# Recall Service Bulletin

**APPLIES TO:** This service bulletin applies to certain MM and K3 models of incomplete motor home chassis built by Spartan Motors USA, Inc. between September 21, 2006 and March 23, 2015.

**NHTSA/TC Id:** 16V-313

**CONDITION:** Flexible exhaust tubes may tear

**FIG. 3-1**

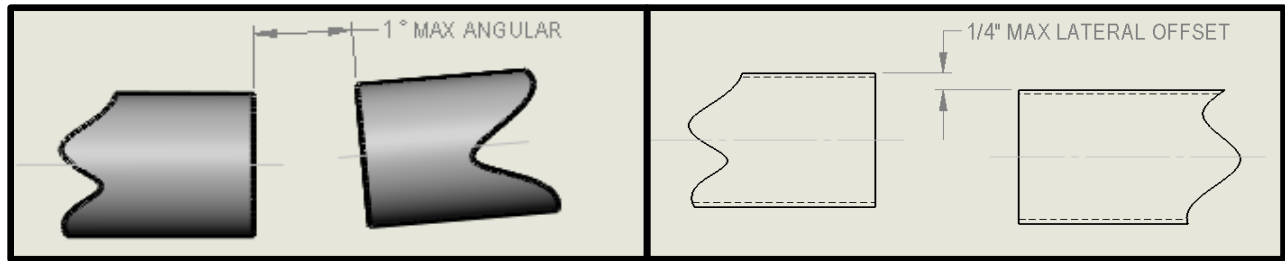
4. Using a straight edge check for alignment of bellows.
  - a. Alignment should be checked in (2) two quadrants on bellows that are 90° from each other. Ex. Top and Side.

- b. Connecting tube alignment for bellows must meet the following requirements:

- Using a straight edge, align tubes and exhaust bellows so they meet requirements for angularity, lateral offset and overall length. The alignment **must** be checked in (2) two quadrants that are 90° apart. Proper alignment **must** be achieved before proceeding, refer to Fig. 3-1 and 3-2.
- Once alignment requirements are met secure all clamps and brackets.

**FIG. 3-2**

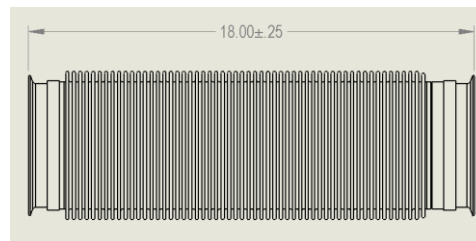
c. Installed length of bellows must be  $18.00 \pm 0.25$ "

**FIG. 3-3**

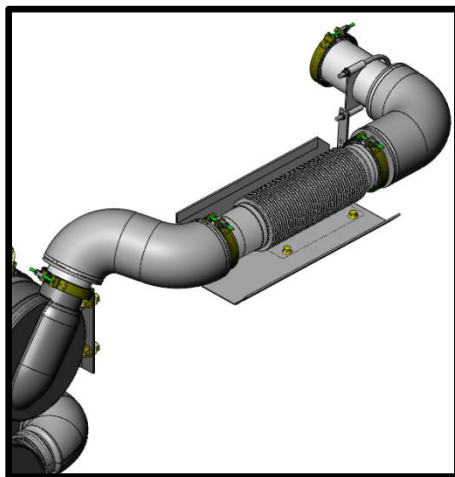
5. If no damage is found but misalignment is present proceed to the next steps.
6. Loosen clamps, support brackets, and v-band clamps that secure tubes to allow for adjustment of the tubes. Refer to 7<sup>th</sup> digit in VIN number for engine identification. If 7<sup>th</sup> digit is D, engine is an ISL: refer to FIG. 3-3. If 7<sup>th</sup> digit is E, engine is an ISX: refer to FIG. 3-4.

ISL installation (shown with bellows as reference)

**FIG. 3-4**

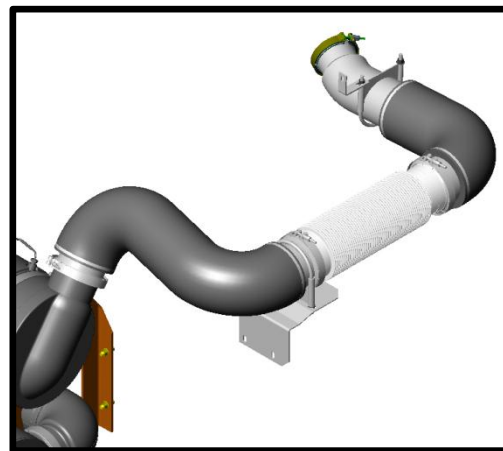
ISX installation (shown with bellows as reference)
